Project Name: New Haven BRF 0183(1)

Structure Identification: TH 2, Bridge 10

The precast concrete fabrication drawings associated with Items 540.10 Precast Concrete Structure (Abutment #1), (Abutment #2), (Approach Slab #1) and (Approach Slab #2) and Item 900.645 Special Provision (Precast Concrete/Steel Composite Pier Cap), has been reviewed and is being returned herewith.

Submittal Notes Rev #1 (To be used when reviewing shop drawing submittal)

1 AS2 DIMENSIONAL PLAN VIEW IN FORM - "RR-AS1"
1/2" = 1'-0"

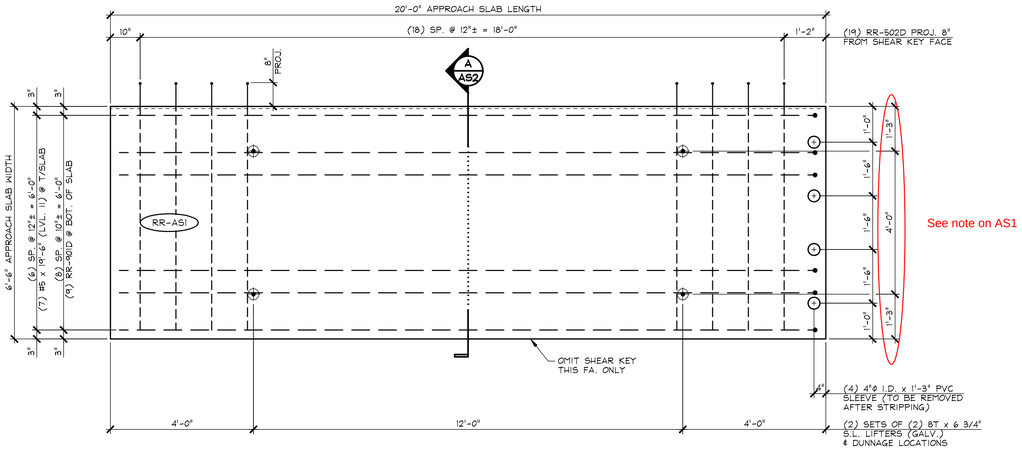
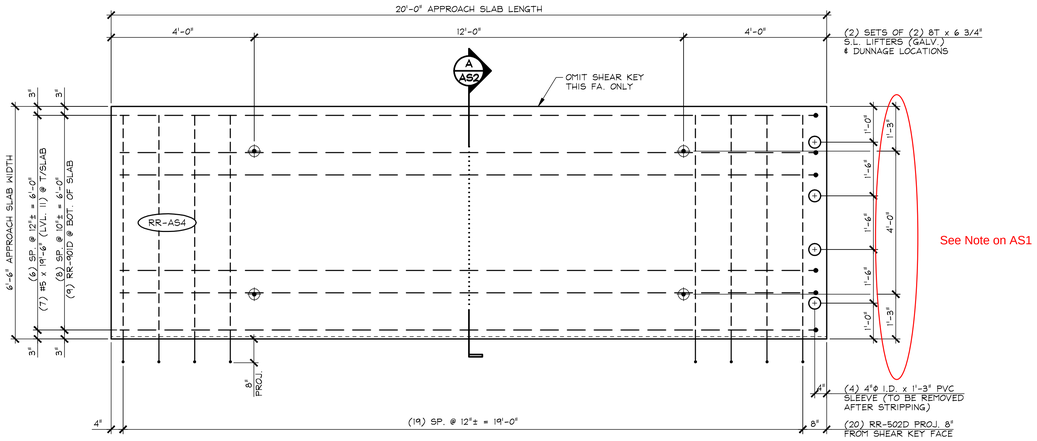
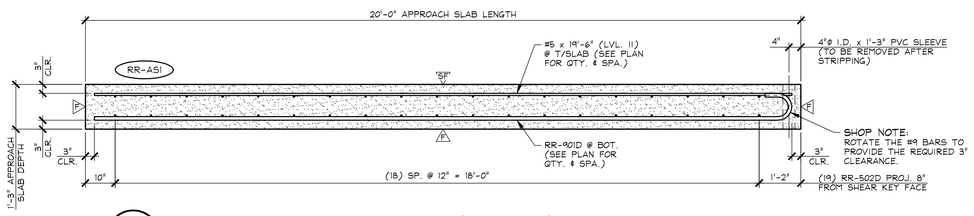
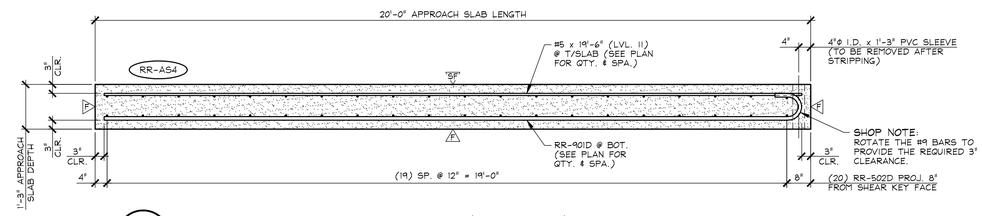
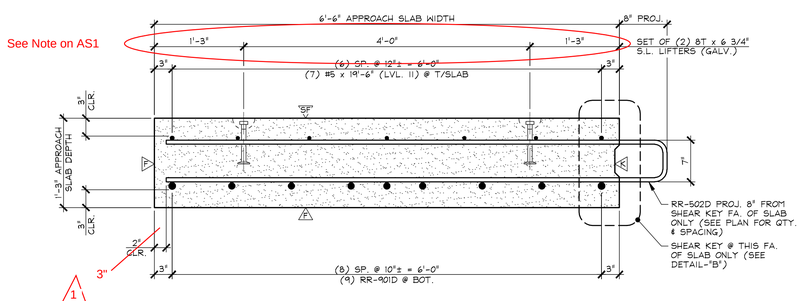
See Note on Sheet F4 regarding this detail.

can't tell what the sheet is supposed to make it more confusing

Only something more relevant since that what the sheet is for, looking at the sheet it is one of the interior

1 PC1 PRECAST CONCRETE PIER CAP PLAN VIEW IN FORM
1/2" = 1'-0"

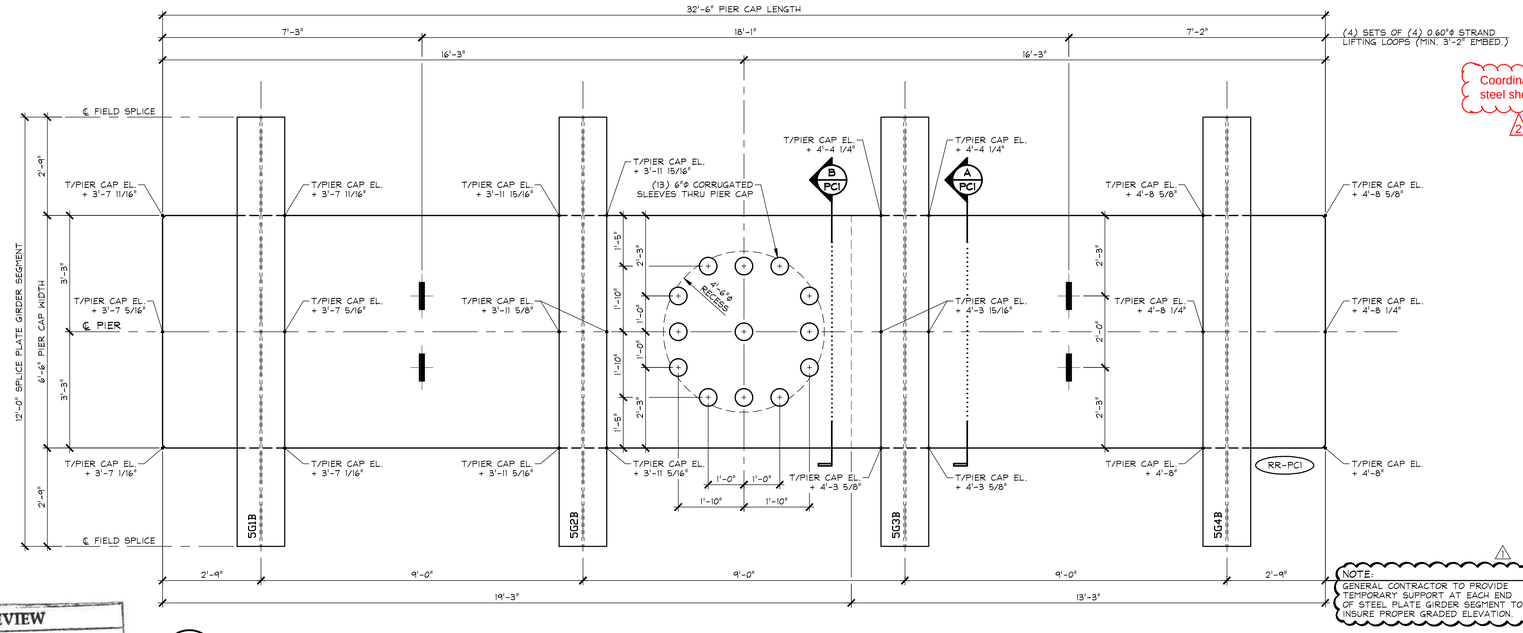
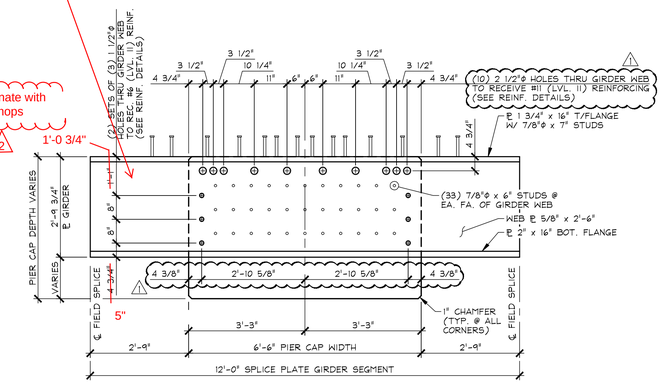
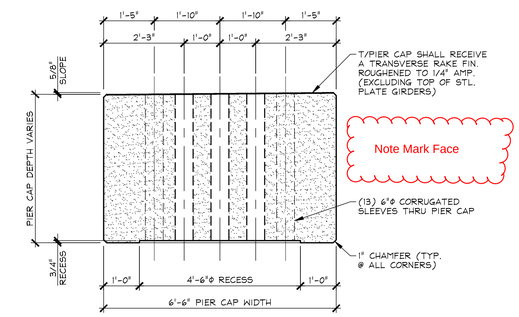
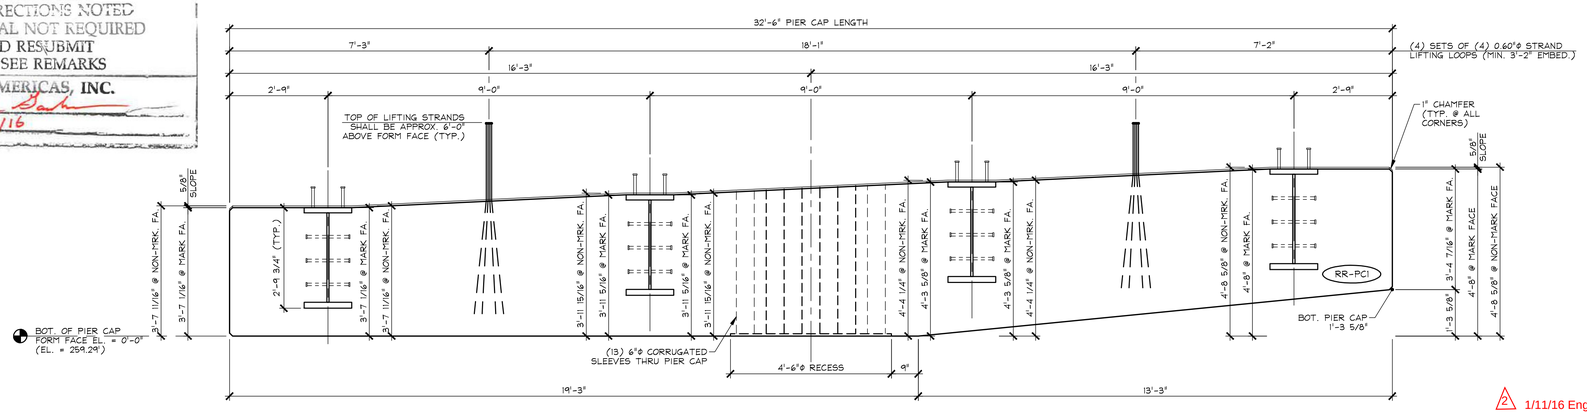
1. **Reference drawing PC1**
   We increased concrete strength to 5,000 psi to allow for a decrease in lap length. Note minimum lap length of 2'-6".

beam at some 5/8" slope as top surface?

Coordinate with steel shops

Note Mark Face

Finishes not indicated

A PCI.1 PRECAST PIER CAP REINFORCING SECTION @ SPLICE PLATE GIRDER SEGMENT 3/4" = 1'-0"

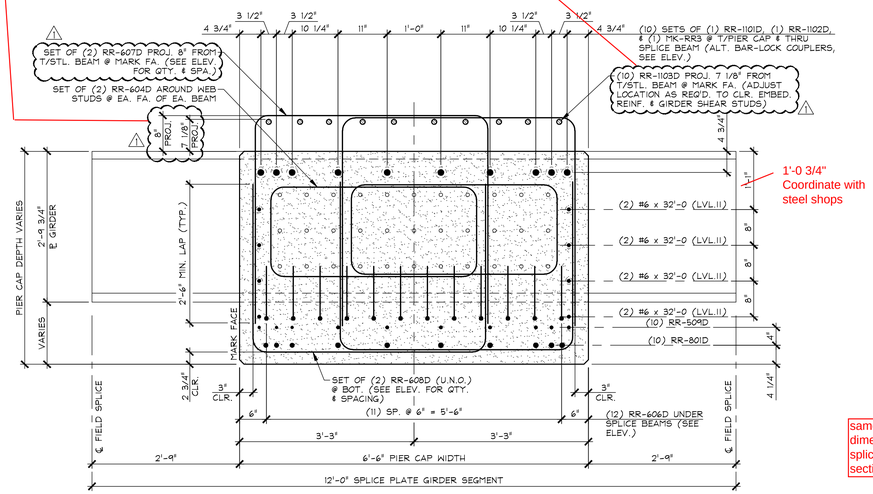
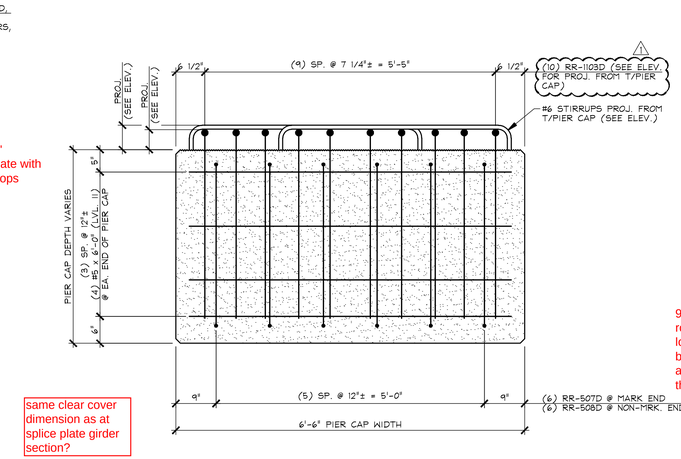
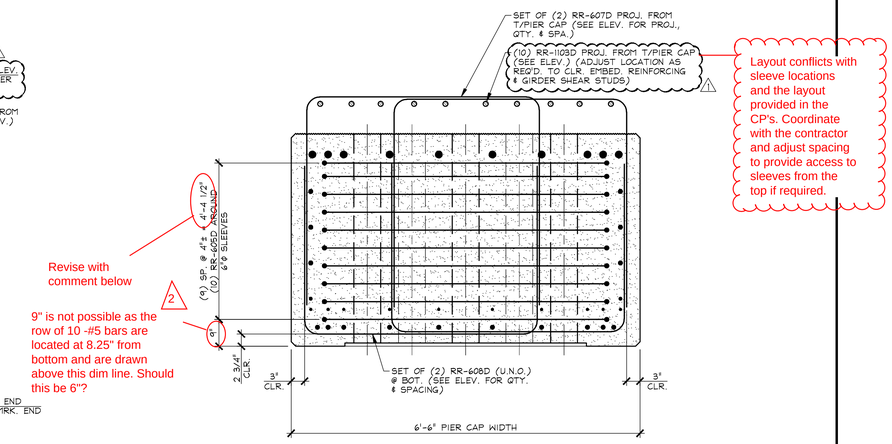
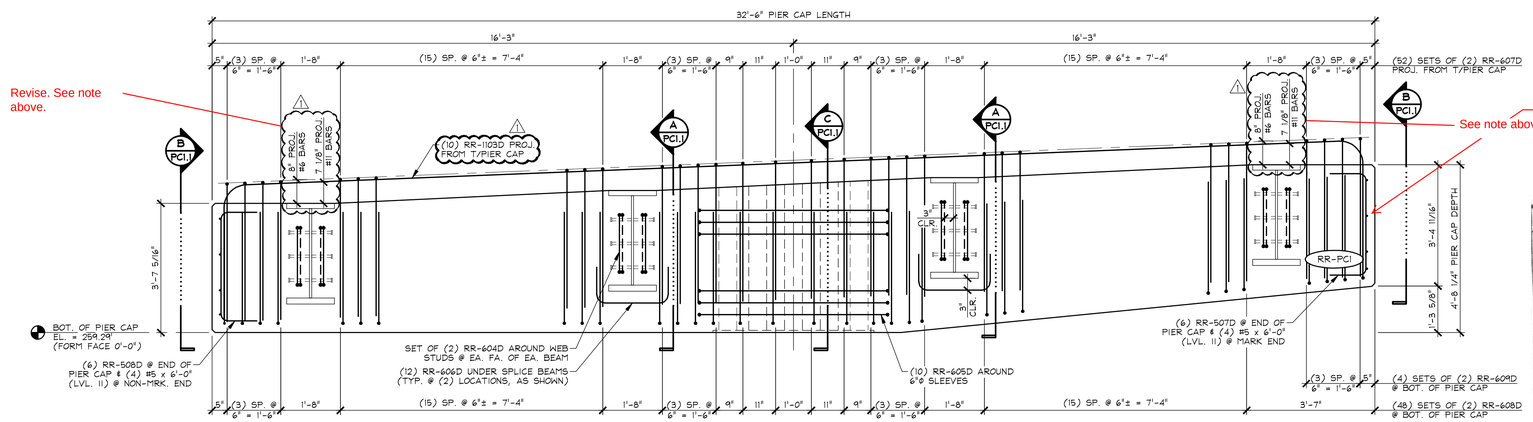
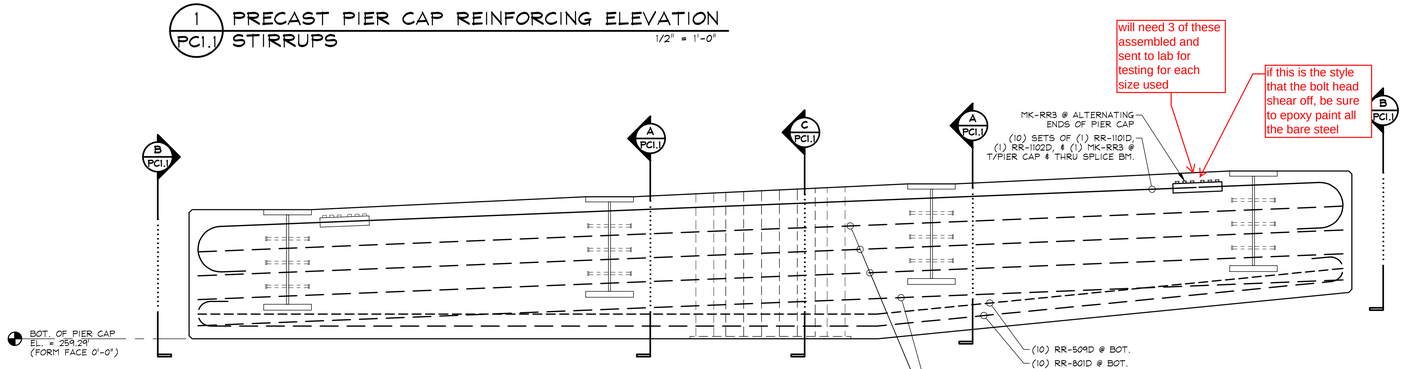
Revise. Assuming an 8" projection of #6 hoops: 8" - 1/2 (6/8) - 1/2(1.41in) = 6.92" projection to CL of #11 bar
Assuming calculation from top of deck: 11" - 2.5"clr - 6/8 - 0.5*1.41 = 7.0" projection to CL of #11 bar, with 8.125" to CL of #6 hoop

1 WW1 PLAN VIEW IN FORM
1/2" = 1'-0"

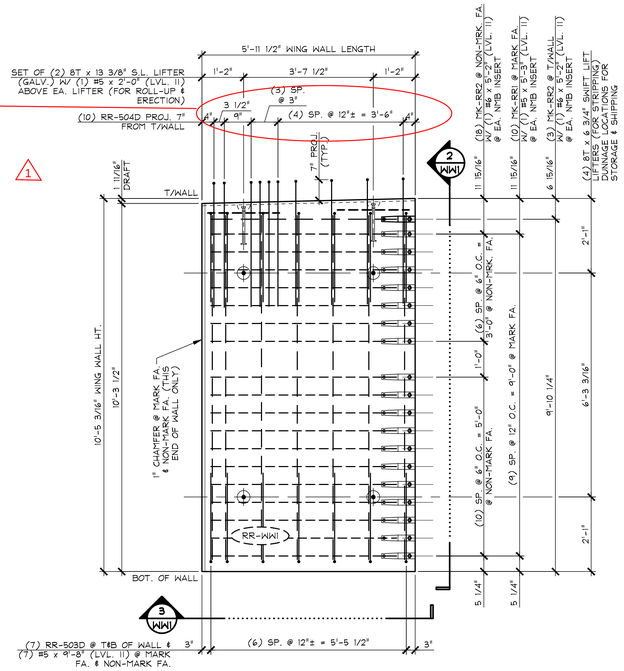
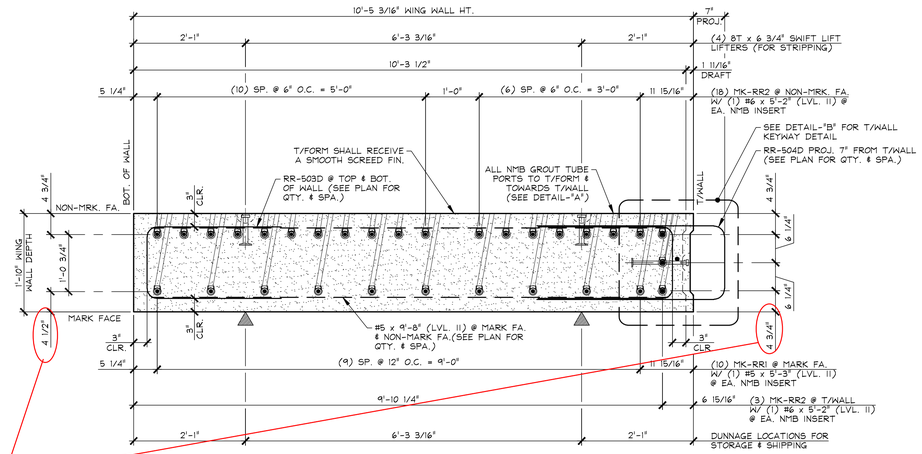
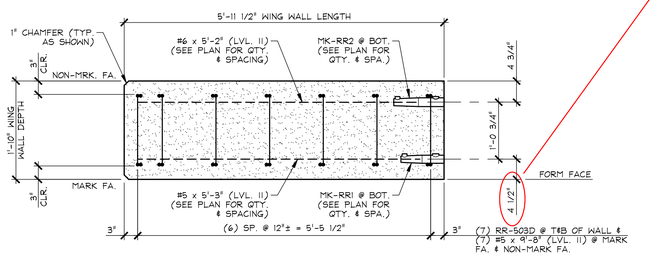
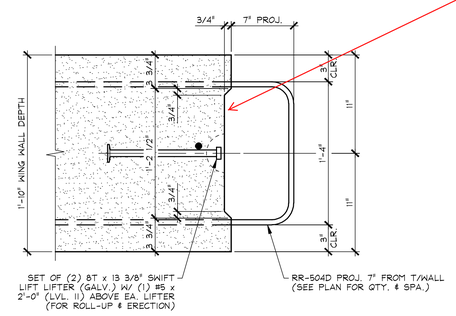
2. **Reference drawing WW1, Detail "B"**
   We have substituted a keyway for the "roughened surface" called out on the contract drawings.

Revise. The 3 additional at rail posts results in 6 spaces at 6" in these regions. See VTrans Standard VT S-360A for schematic.

3 cover+6/8" + 0.5*1.89" = 4.695" > 4.5.
Adjust locations of bars in abutment caps to correspond with change.
Adjust dimension to grout tubes accordingly.

surface amplitude?

1 WW2 PLAN VIEW IN FORM
1/2" = 1'-0"

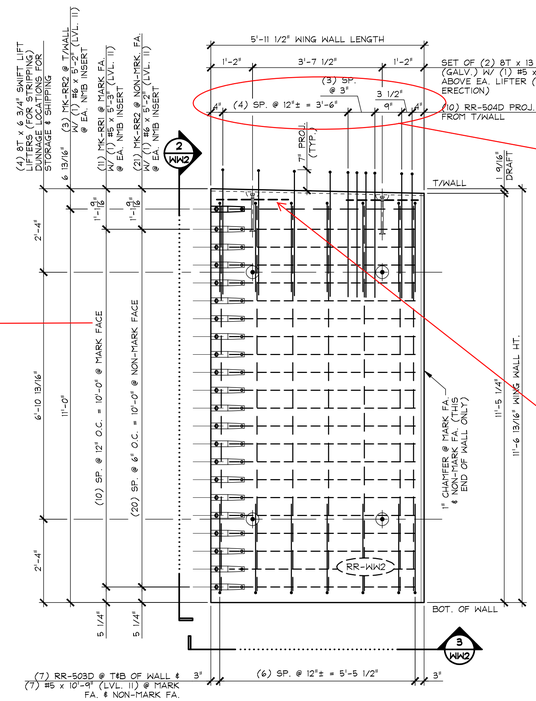
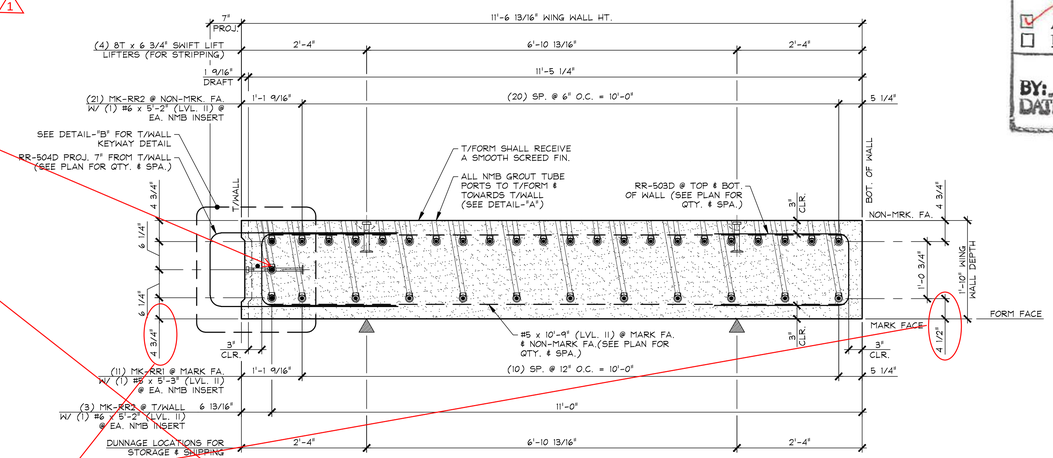
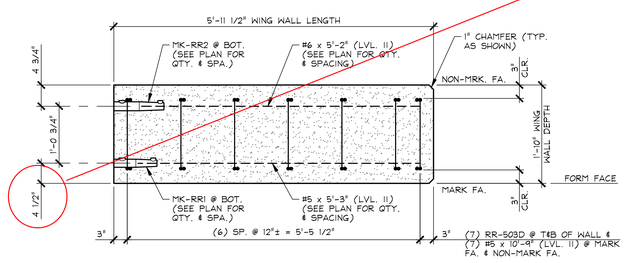
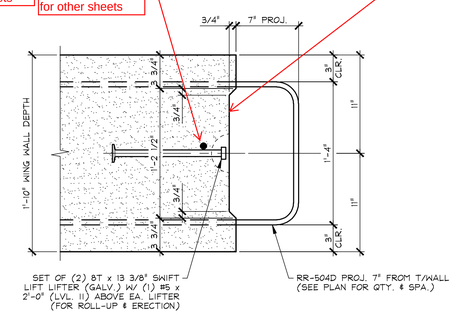
Spacing as is leaves 1.875" from CIP/PCU joint to centerline of 1st bar in CIP abutment section.

Revise. The 3 additional at rail posts results in 6 spaces at 6" in these regions. See VTrans Standard VT S-360A for schematic.

3 cover+6/8" + 0.5*1.89" = 4.695" > 4.5. Adjust locations of bars in abutment caps to correspond with change. Adjust dimension to grout tubes accordingly.

1 WW3 PLAN VIEW IN FORM
1/2" = 1'-0"

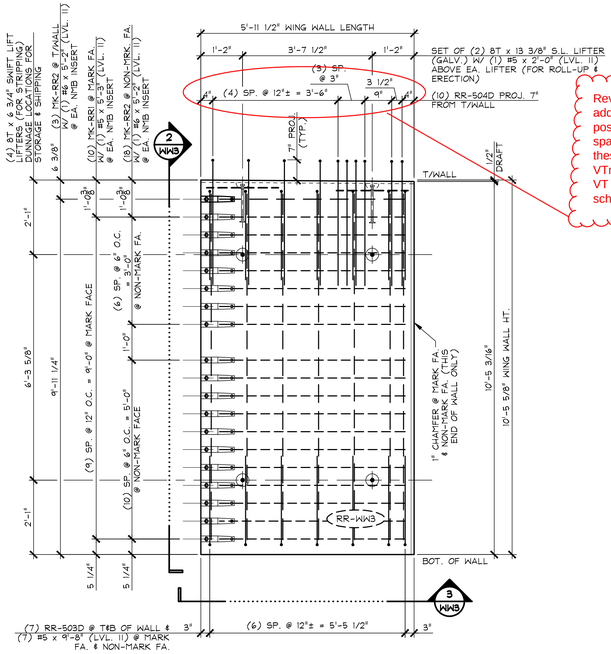
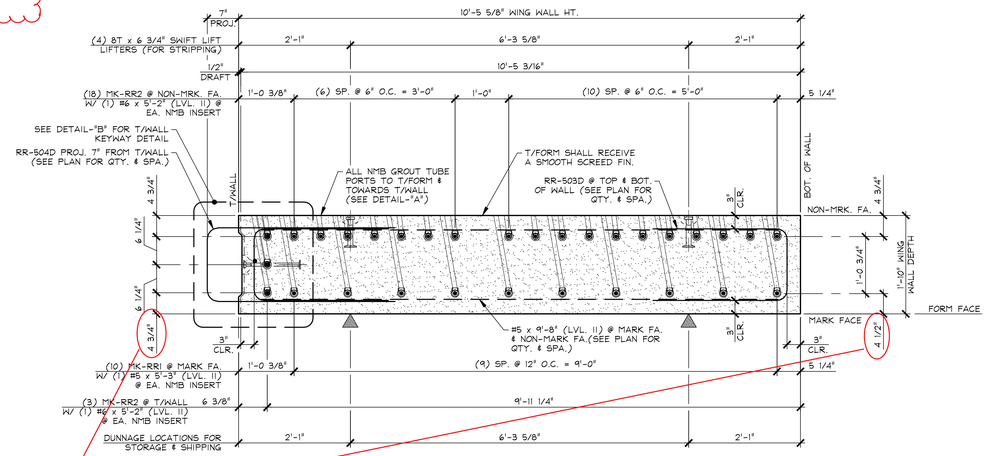
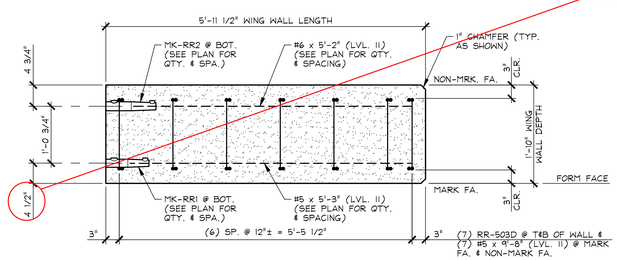
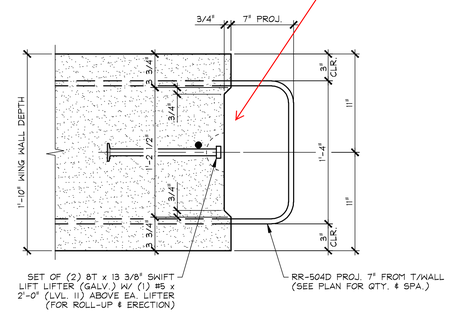
3 cover+6/8" + 0.5*1.89" = 4.695" > 4.5.
Adjust locations of bars in abutment caps to correspond with change.
Adjust dimension to grout tubes accordingly.

surface amplitude

Finishes not indicated

1 WW4 PLAN VIEW IN FORM
1/2" = 1'-0"

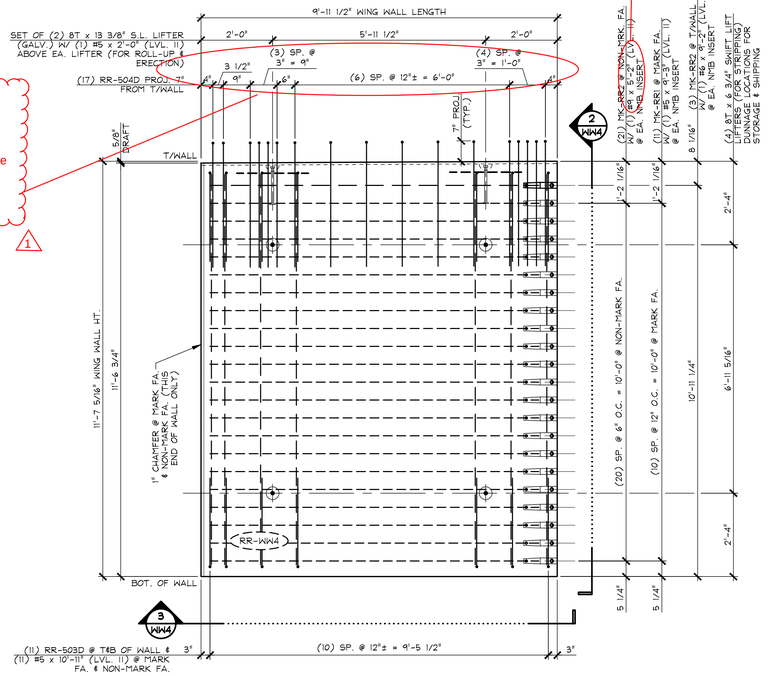
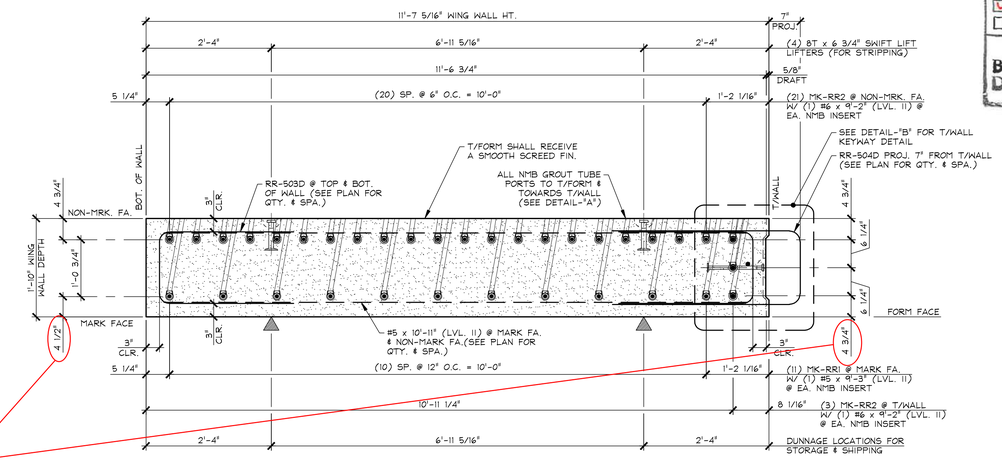
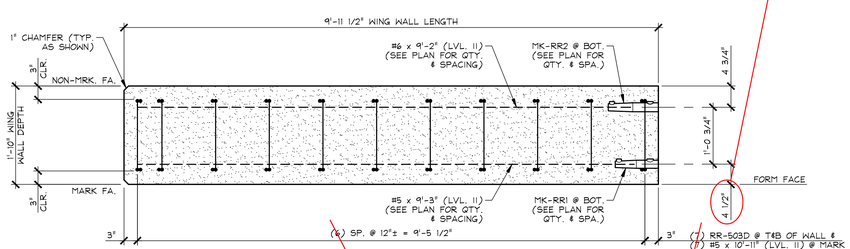
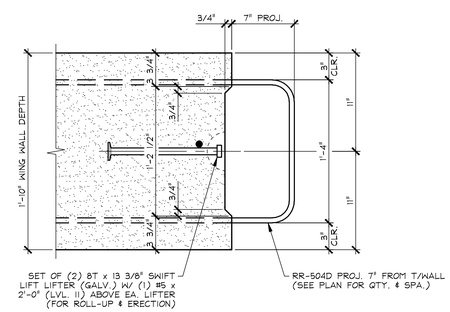
Revise. The 3 additional at rail posts results in 6 spaces at 6" in these regions. See VTrans Standard VT S-360A for schematic. 1

1 3 cover+6/8" + 0.5*1.89" = 4.695" > 4.5. Adjust locations of bars in abutment caps to correspond with change. Adjust dimension to grout tubes accordingly.
